# United Consultants, Inc.

**Re: 70, 72, 88 and 94 East Central Street  
Site Plan and Special Permit Application Peer Review**

**Re: 70, 72, 88, and 94 East Central Street  
Site Plan Peer Review Update**

DATE	MAR. 4, 2020
SCALE	1" = 20'
PROJECT	UC1334
SHEET	3 of 9

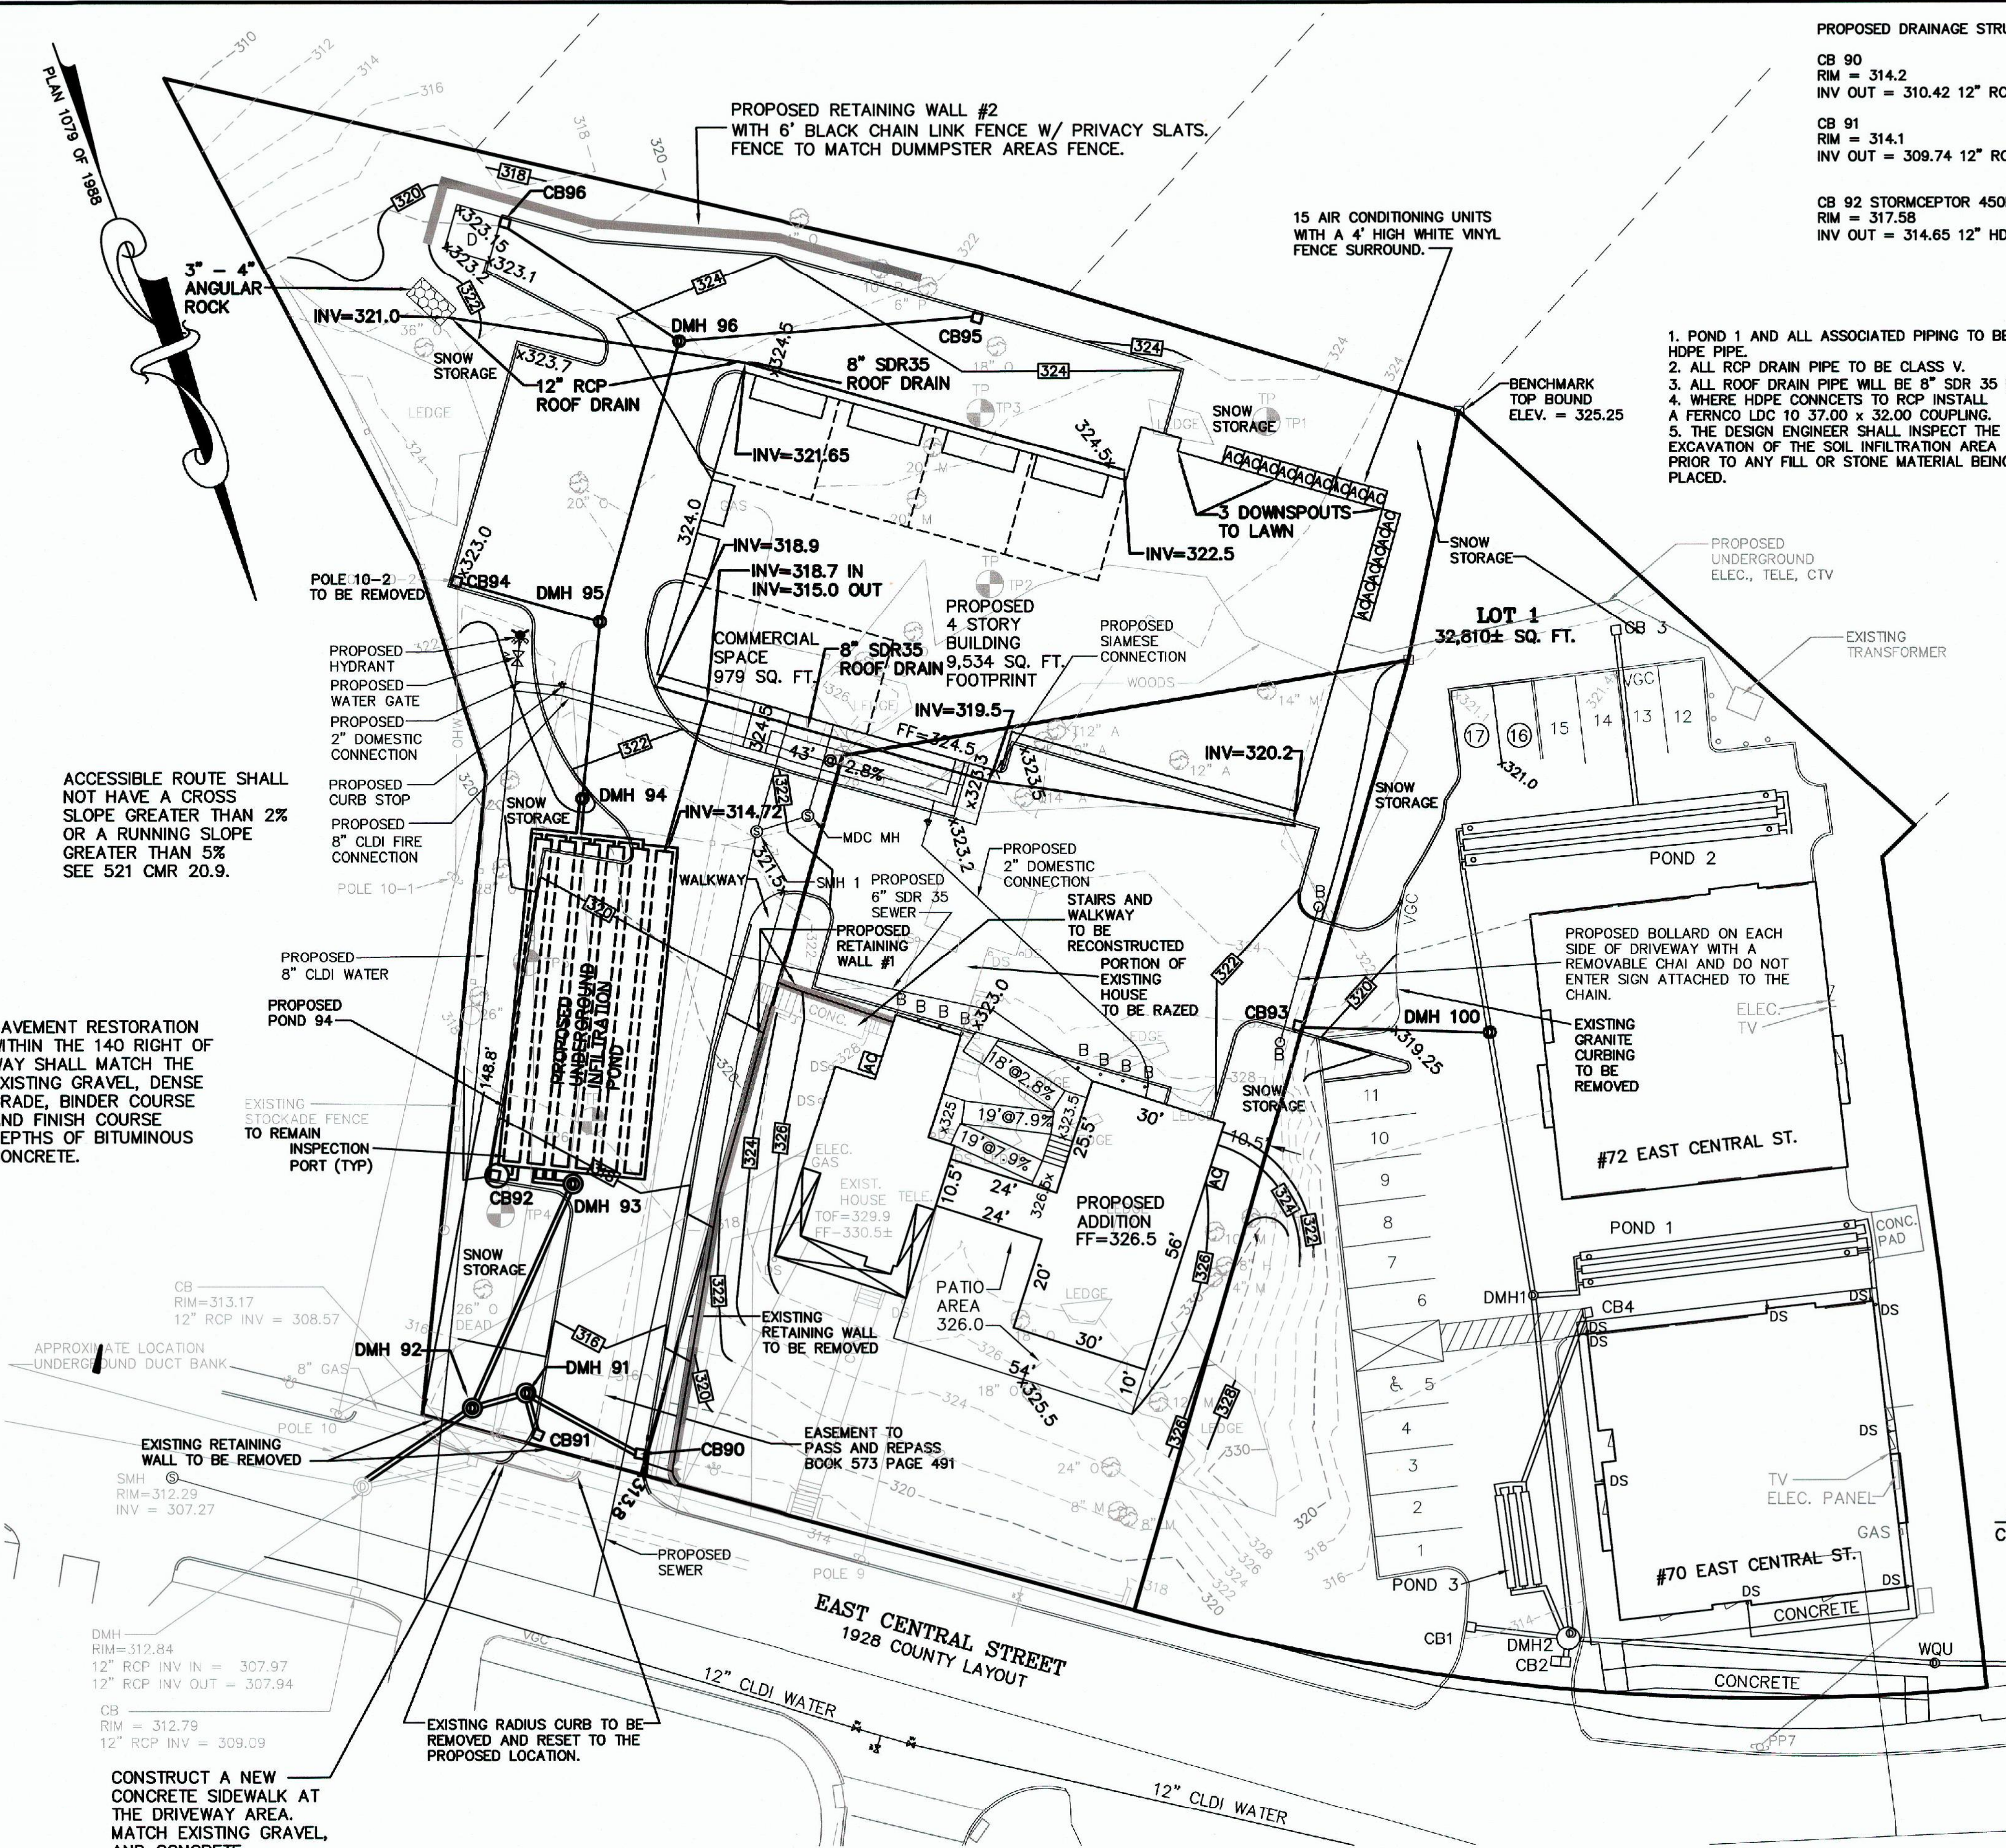
Z1. Revise the Residential Density calculations on Sheet 3, which should be reflective of any combined lot areas and the correct number of proposed and total dwelling units. The calculation should also reflect the differing densities permitted in the CI and DC districts.

P2. Provide the layout for the proposed 10-space parking garage.

*The Residential Density calculations have been revised and are based on the current lot sizes. Refer to calculations and notes on Sheet 3.*

The nine parking spaces have been added to the garage area. Sheet 3.

*A cross walk has been added. Sheet 3.*

DATE	MAR. 4, 2020
SCALE	1" = 20'
PROJECT	UC1334
SHEET	4 of 9

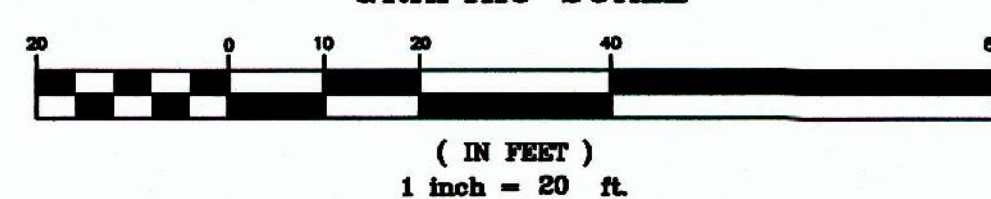
SW1. Provide the size/material for the roof leader connections to the subsurface infiltration system.

SW4. Provide spot grades at the concrete dumpster pad to show positive drainage toward CB96.

*Additional labels have been added. Sheet 4.*

*The contour has been added. Sheet 4.*

*Spot grades have been added. Sheet 4*

DATE	SCALE	PROJECT	SHEET
MAR. 4, 2020	1" = 20'	UC1334	5 of 9

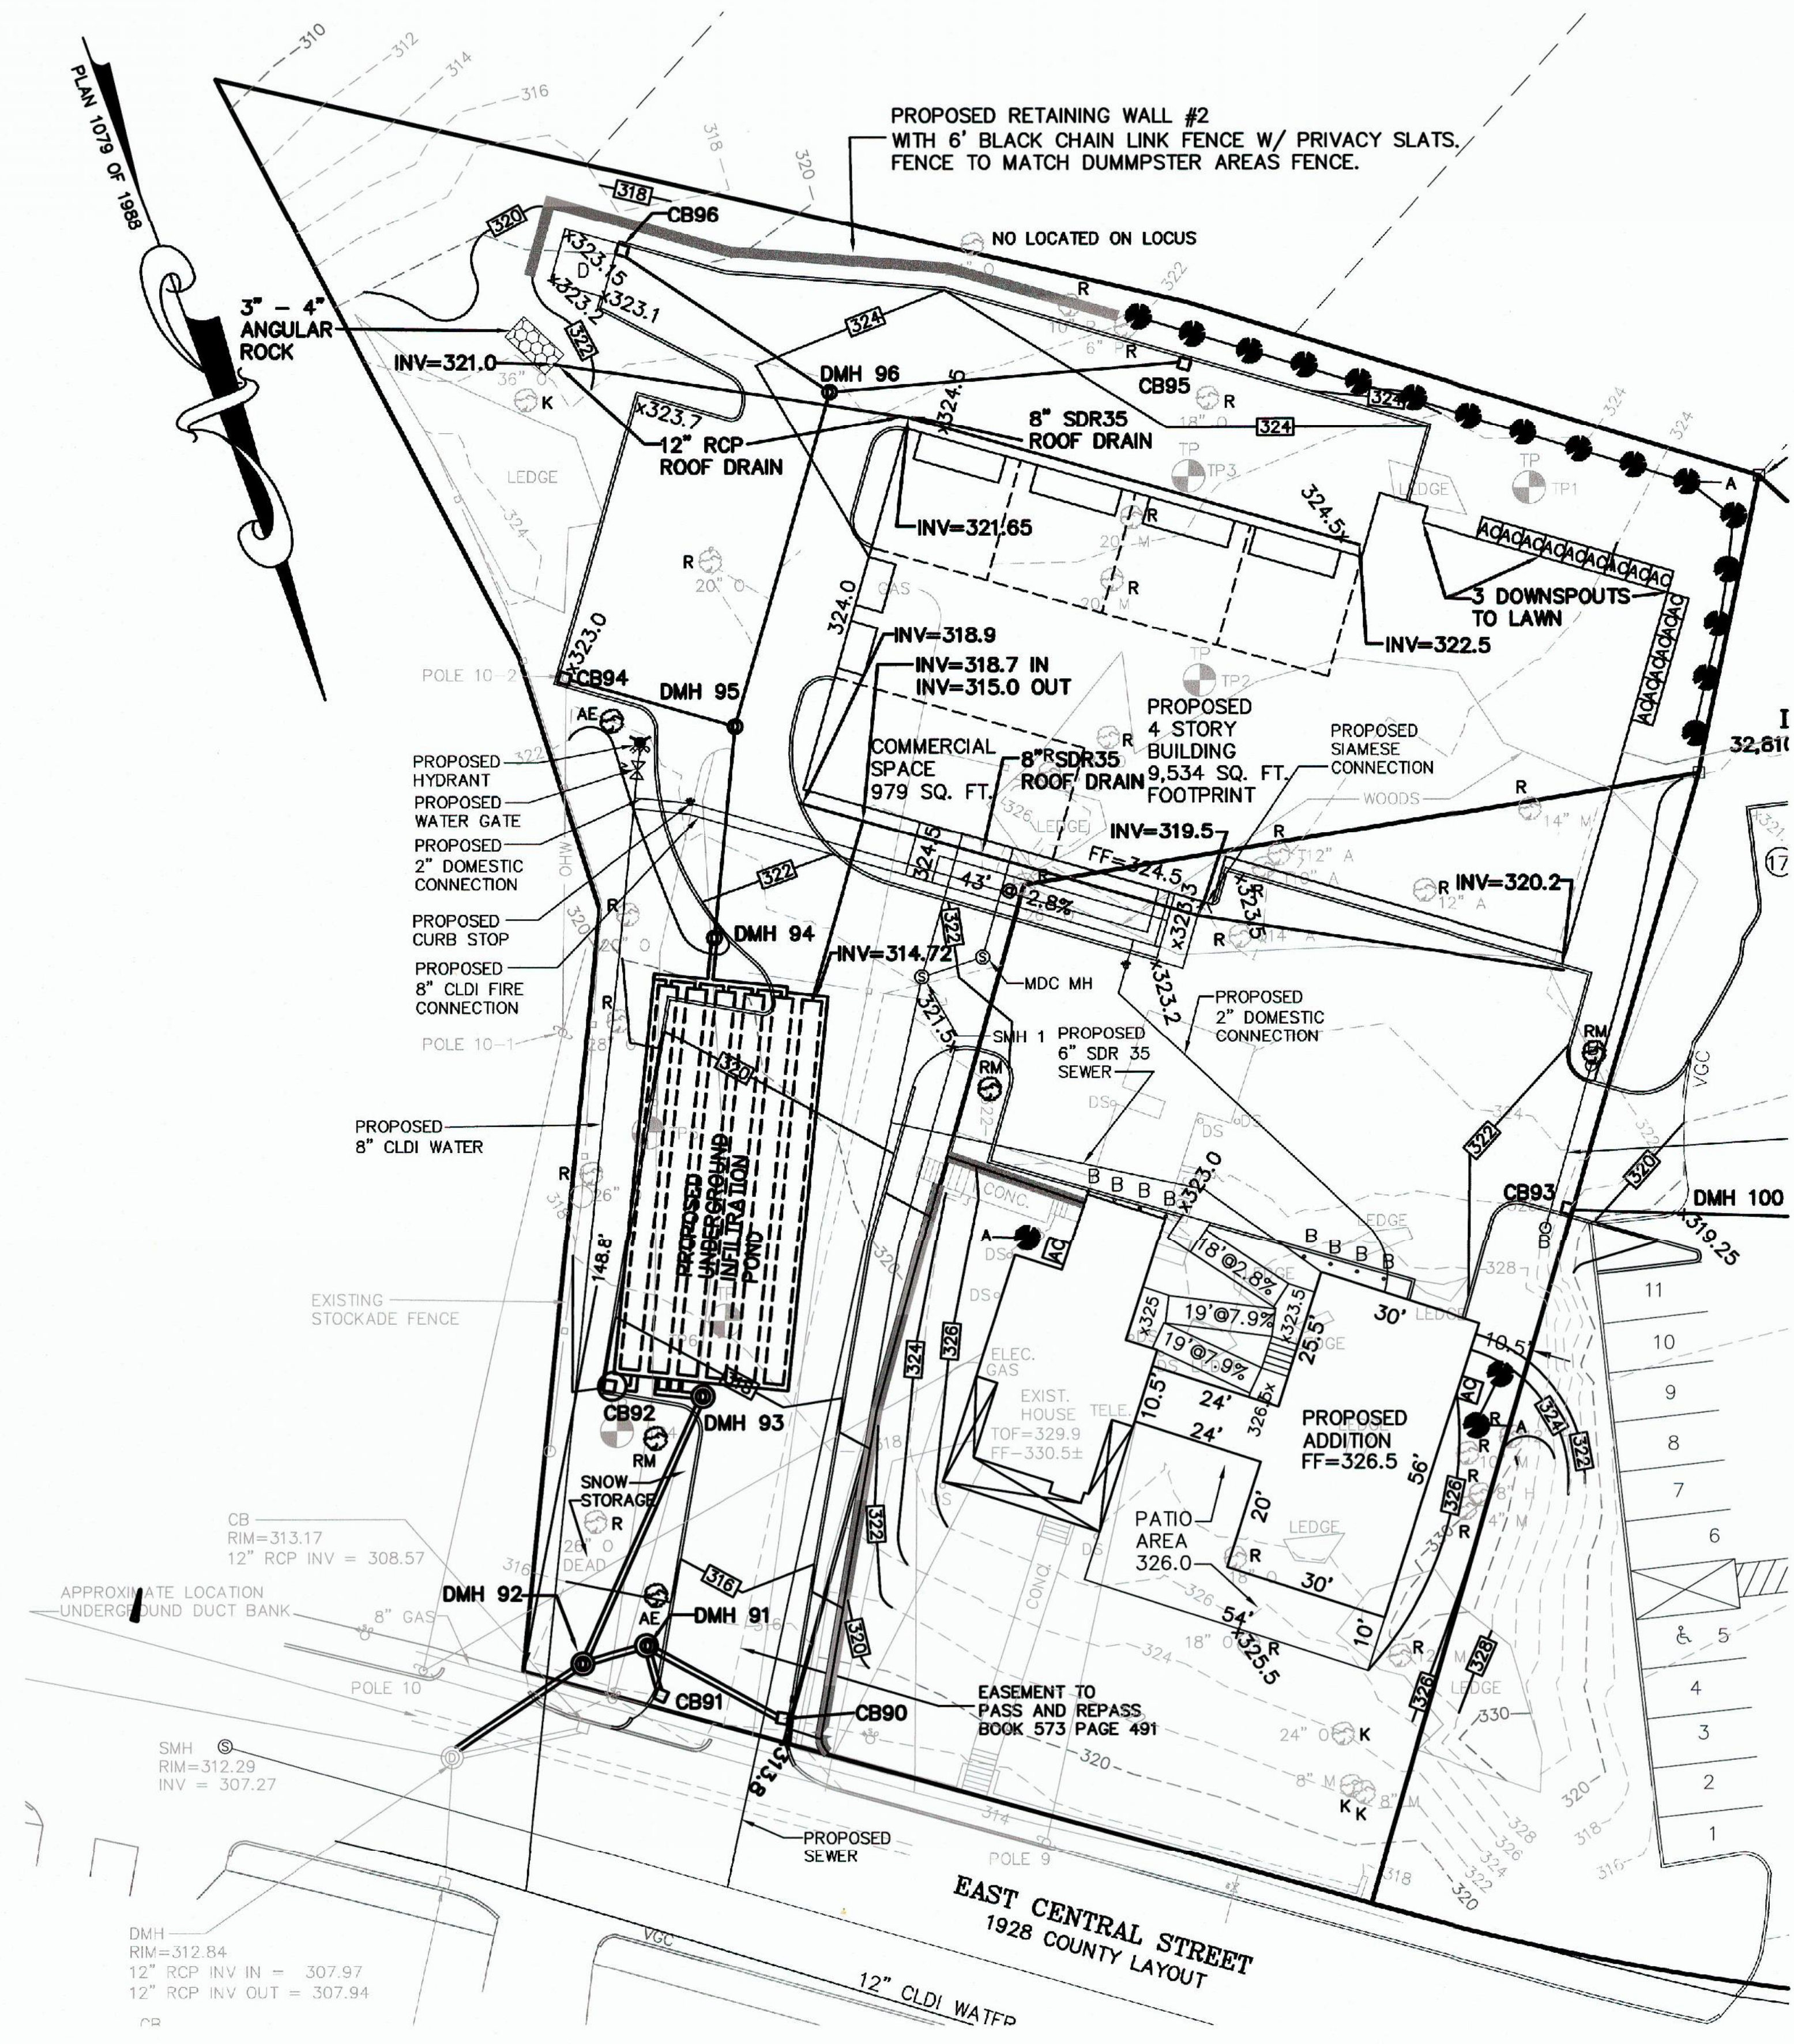
PB 4. Add Arborvitaes at the right rear building corner 94 ECS.

*Additional arborvitae's have been added. Sheet 5.*

*Additional arborvitae's have been added. Sheet 5.*
